RISO, INC. **TECHNICAL INFORMATION BULLETIN**

Subject: DRUM LOCK WILL NOT RELEASE **BULLETIN NO.: 097**

SUBJECT: Actions to correct Unreleased Drum Lock

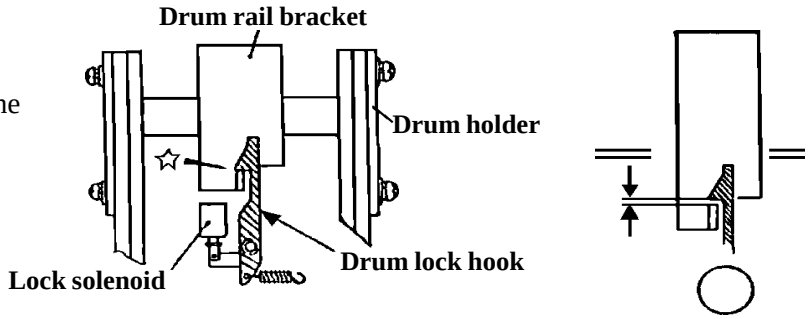
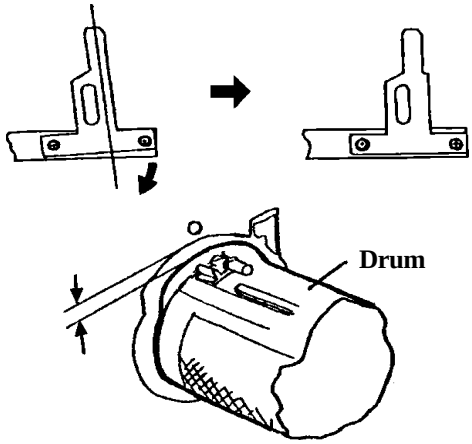
Phenomenon:
The drum can't be pulled out of the machine at the drum home position.

Cause 1:
The Drum lock hook is in contact with the hook of the Drum rail bracket, which prevents the Drum lock hook from being pulled aside by the operation of the Lock solenoid.

Action:
Loosen the mounting screws on the Drum holder and turn down the Drum holder to make space between the Drum lock hook and the Drum rail bracket.

After adjusting the mounting position of the Drum holder, always confirm that the Drum can be inserted into the machine without contact with the machine frame.

If the Drum comes in contact with the machine frame after the mounting position adjustment of the Drum holder, return the Drum holder to the original position and file the hook of the Drum rail bracket to make space.

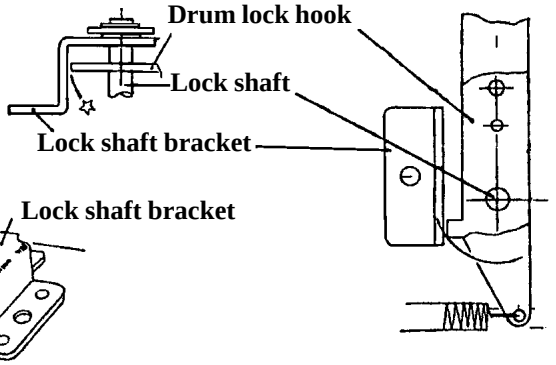
Cause 2:
The protruding part of the Drum lock hook (deep inside the machine) gets stuck on the inner side of the Lock shaft bracket due to the rough edges of the protruding part and the shaft hole of the Lock shaft bracket.

Action:
File away the rough edges of the parts indicated by the circled numbers 1 and 2.
